Rezoning Transportation Analysis

Petition Number: Zoning Petition #2021-004

General Location Identifier: Tax ID 08117410

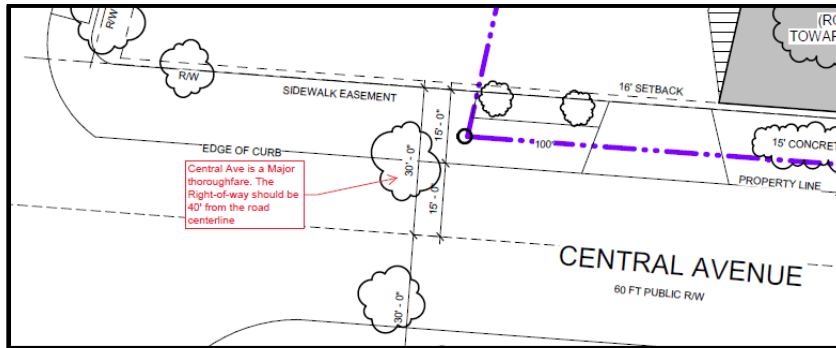
3. ~~Revise Site Conditional Note, II. Optional Provisions, to include how additional parking will be accommodated off-site, since on-street parking spaces are limited in this area. This will ensure that the existing community is not adversely impacted by parking spilling over into Pecan Avenue and adjacent streets.~~
